**WORCESTER HOUSING AUTHORITY**

**ADDENDUM NO. 1**

**Entry Door Replacement**

**WHA Job No. 2017-22**

**A.2**

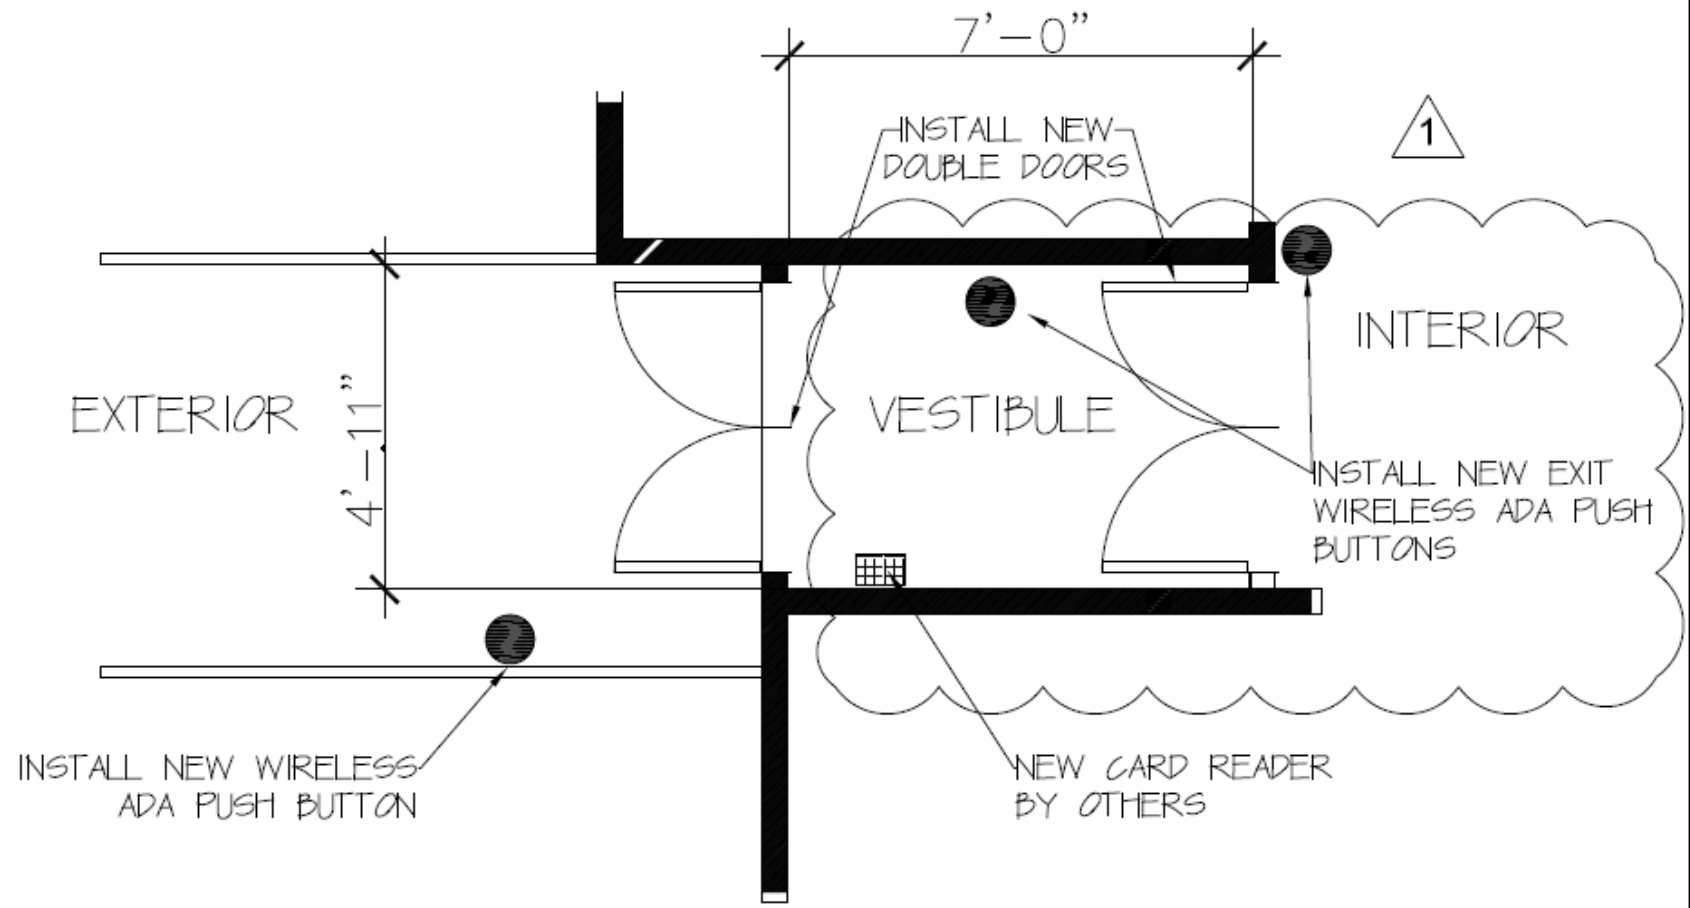
2. **ANSWER:** *Two (2) full opening double doors. The openings are roughly 4'-11" x 6'-8", contractor must verify dimensions in the field.*
3. **QUESTION:** To control the door power operators you have 1 push button on the outside of building and one key card located in the vestibule. A) Is your intent to have a separate control paddle inside the building to exit? B) Is the card reader going to release whatever locking mechanism and activate the interior door?

3. **ANSWER:**     A) Yes (see Plan A2).  
                      B) Yes.

**ITEM No. 1: A.1 (PLAN)**

**DELETE:**

*New Doors Detail.*

**INSERT:**

*A.2 New Doors Detail (Revision 1).*
